A. A. Takla Engineering, PLLC

Project: 57 Inlet View
Location: Sanford, NC
Company: Freys Building and Remodeling
Care Of: Jeff Greer
Subject: Renovation - Structural Modifications
Job Number: 0290-23

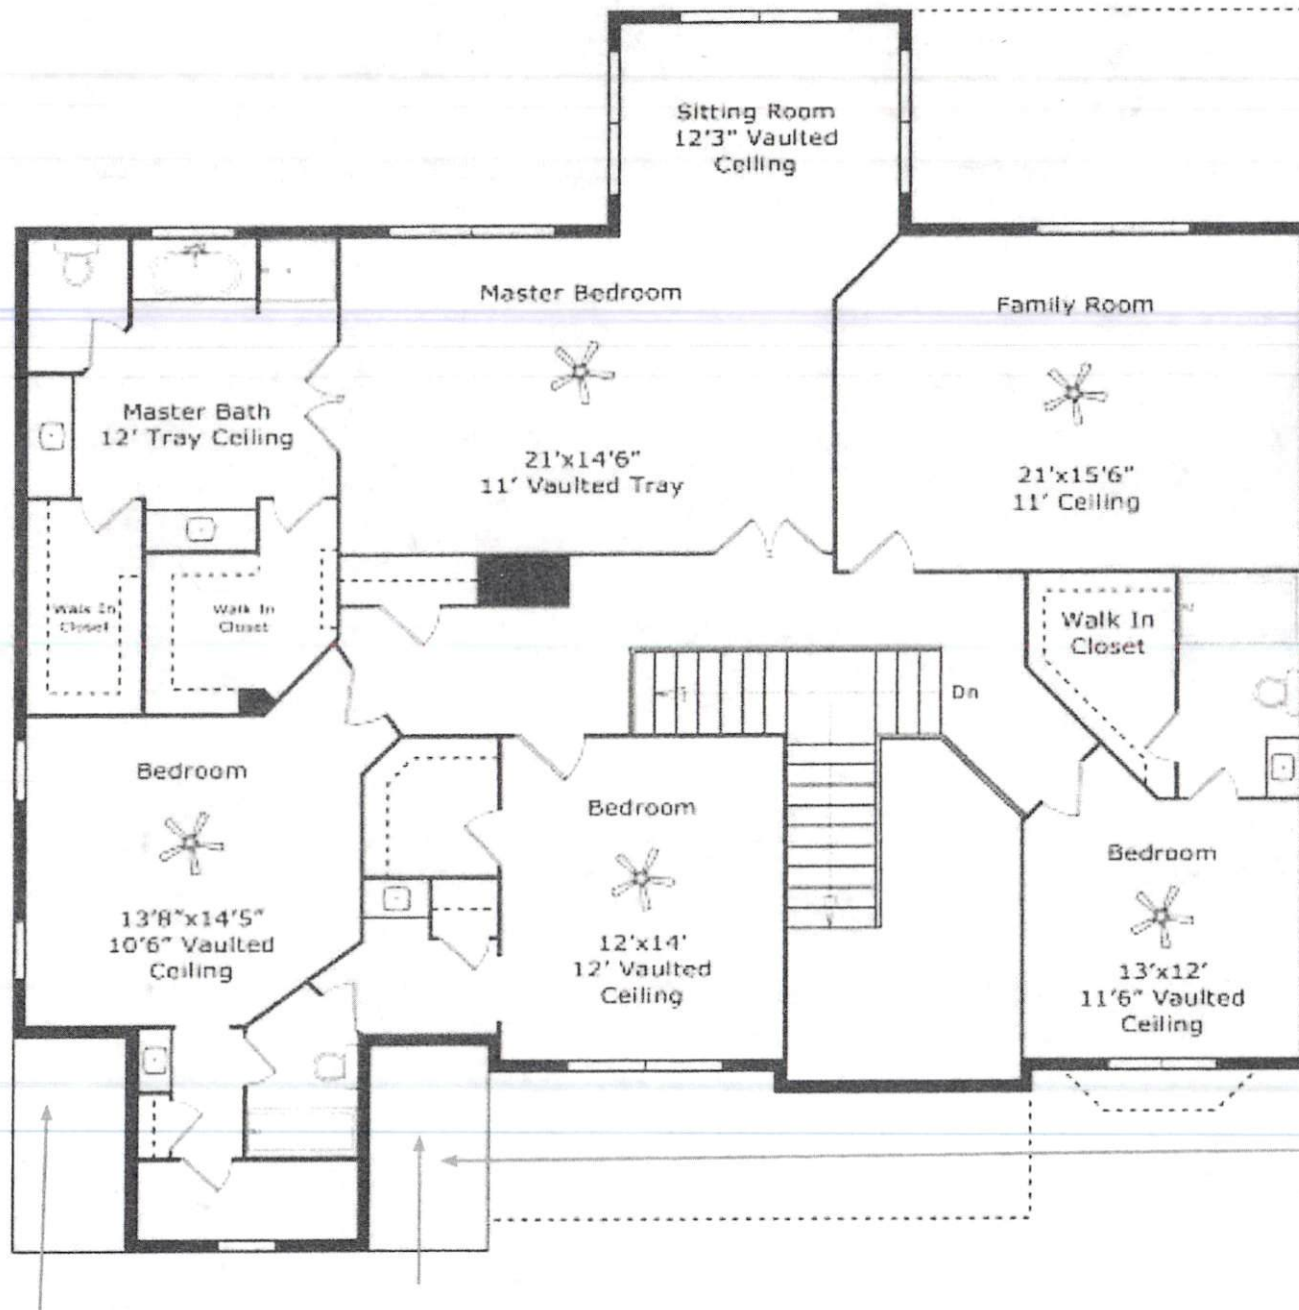
1) Several windows, interior doors and the master bathroom shower niches will be installed and/or relocated. Based on review, put simply, a (2)2x10 header supported by (2)2x4 jack studs at each will be adequate to accommodate all openings (non of which are over 6' wide). Note, the master bathroom niches should end no closer than 12" from the rear-left corner of the 2nd story in neither the left exterior wall or the rear exterior wall. Ensure exterior openings feature king studs per code (at least 2 at each end for openings of 6' wide). Lastly, no reinforcements within the 1st story will be required to accommodate the change in loading configuration given their generally light loading.

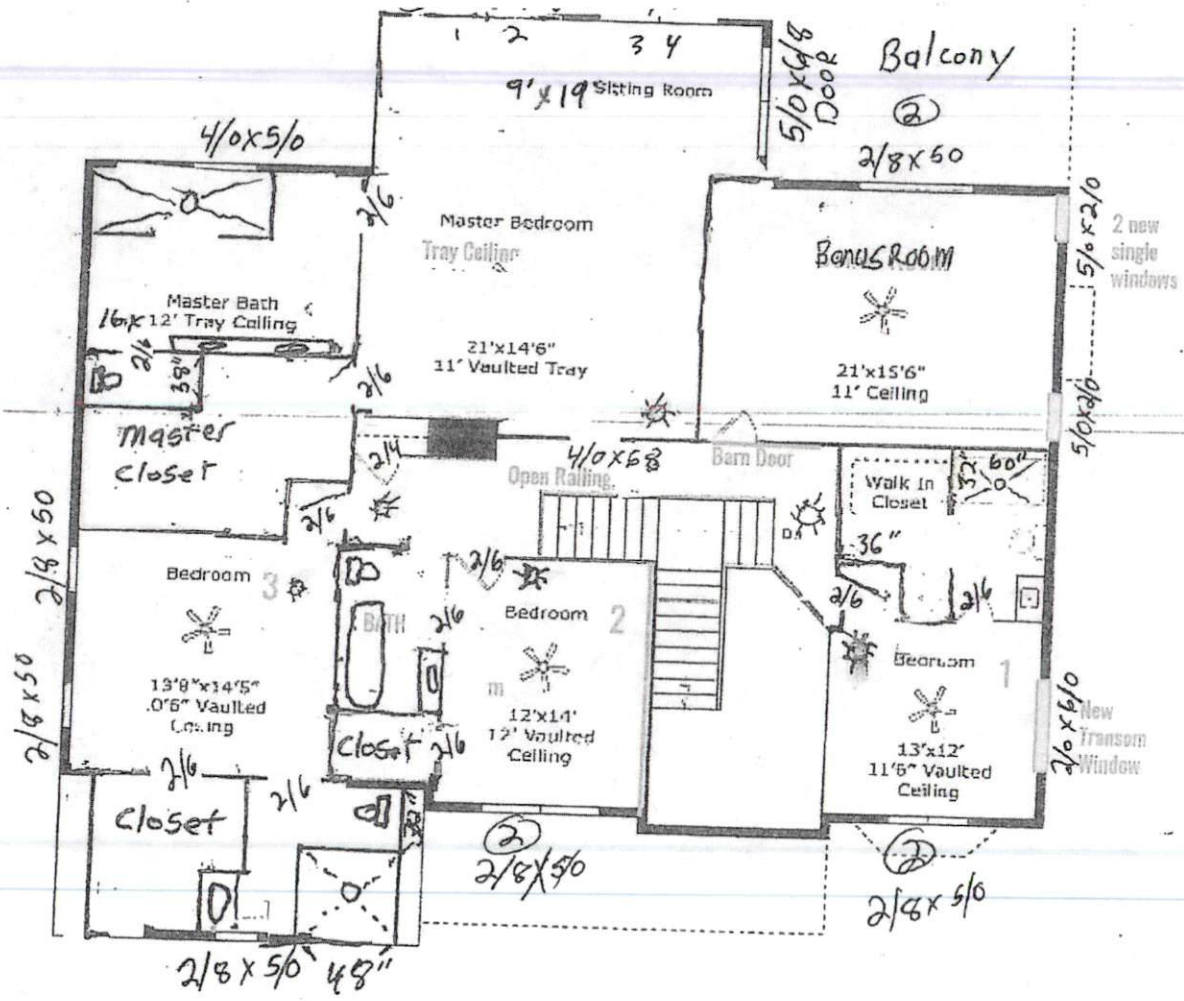
2) While several sections of walls will be relocated (including several diagonal walls which will be squared off), the only ones which should be discussed in this report are at the following areas:

A) To move the right master bathroom wall ~ 3' to the right, we recommend installing either a (2)14" LVL or (3) 11 7/8" LVL at the location of the existing wall. The header may be flushed or dropped as desired and will span ~ 14.5'; Header shall be supported by (3)2x4 jack studs at each end. If 3 ply option is selected and flushed, secure with (5) 10d nails spaced at 12" on center driven from both faces. In the first story hallway, below the forward stud column, install at least (5) 2x4 studs within the hallway wall; providing solid blocking to the first story wall wall. No first story reinforcements are required to accommodate the rear end point load.

B) At the room above the garage, the existing 8' tall left/right side walls will be shifted outward, turning into a 5' knee wall. To accommodate this, we recommend scabbing each rafter from the new location of the 5' knee wall to the ridge. Attach with (3) 10d nails at 12" on center.
